Public Service  
Company of Colorado

July 24, 1985  
Fort St. Vrain  
Unit No. 1  
P-85261

SUBJECT: Cycle 4 Base Reactivity  
Curve And Rod Withdrawal  
Sequence

Figure 19  
Adjustment to Base Reactivity  
As a Function of Fuel Temperature

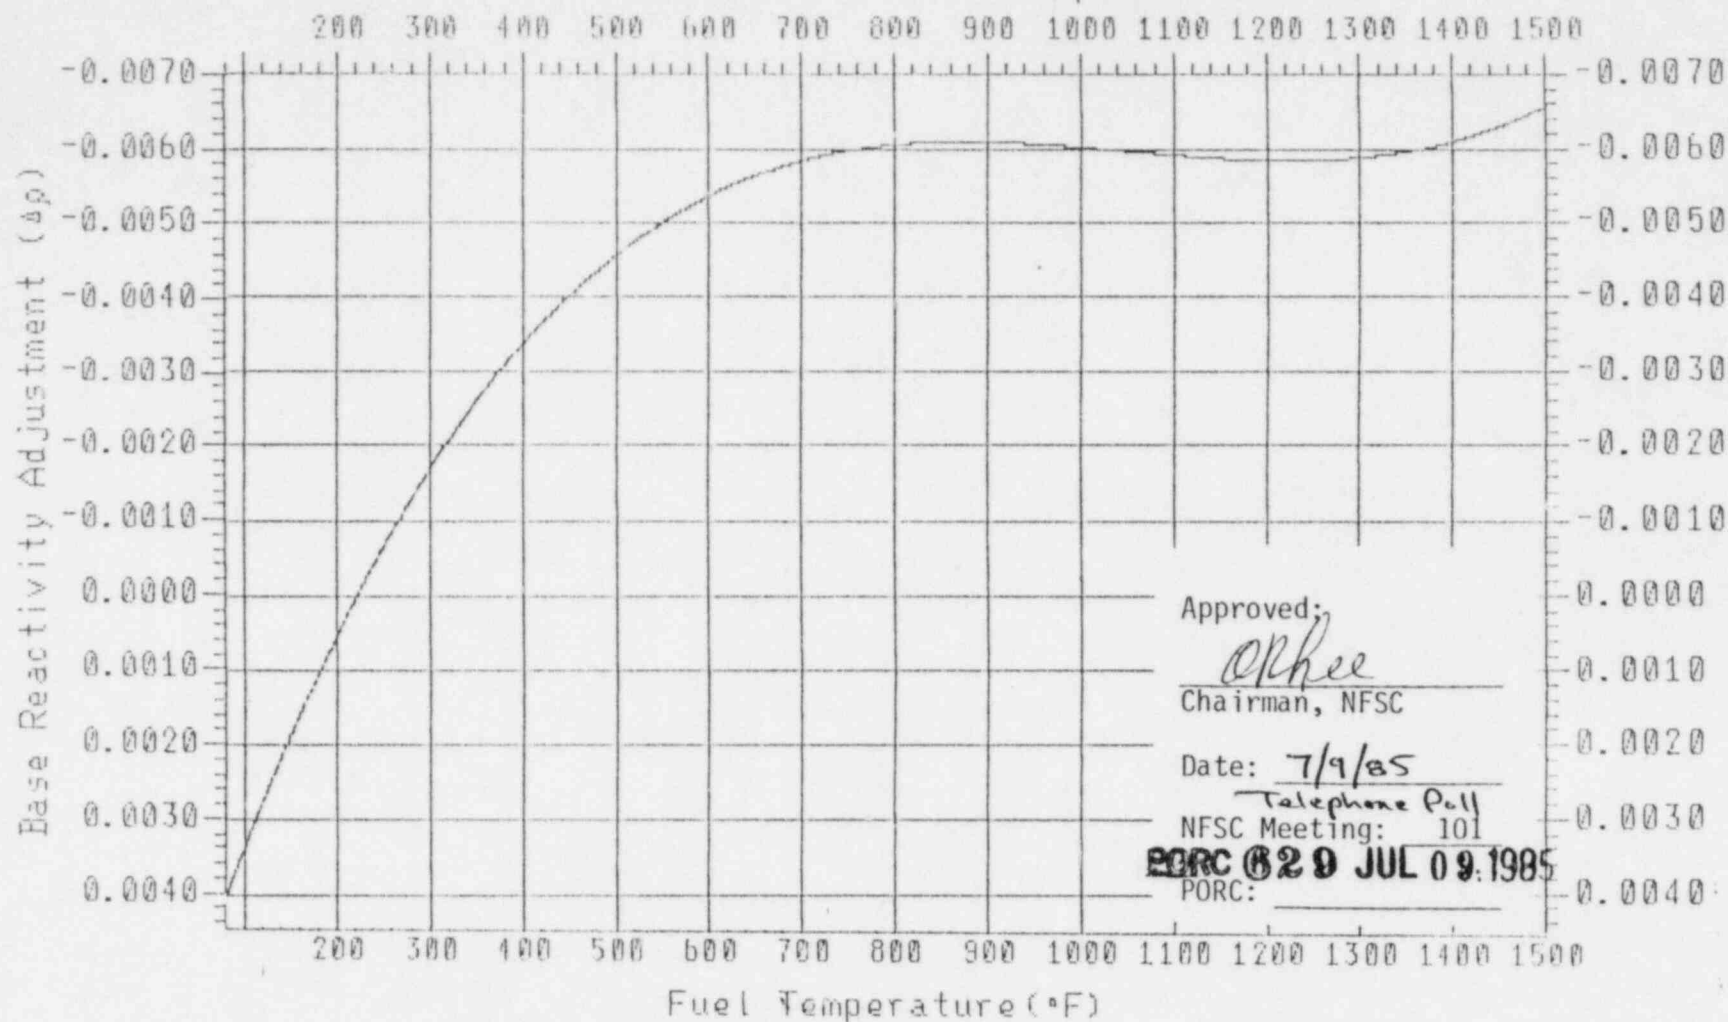
In accordance with the requirements of LCO 4.1.8 of the Fort St. Vrain Technical Specifications, I am transmitting a revised Base Reactivity Curve (Figure 18), correcting a typographical error on the x-axis, and a new Figure 19, incorporating a fuel temperature dependent adjustment to base reactivity, which incorporates an adjustment to Figure 18 based on empirically determined trends to the 4-thermal neutron group GAUGE code base reactivity. Extensive evaluations by GA Technologies (GAT) and Public Service Company (PSC) have resulted in this new Figure 19. It is felt by both Public Service Company and GA Technologies that use of this figure will improve the accuracy of modeling the core reactivity status.
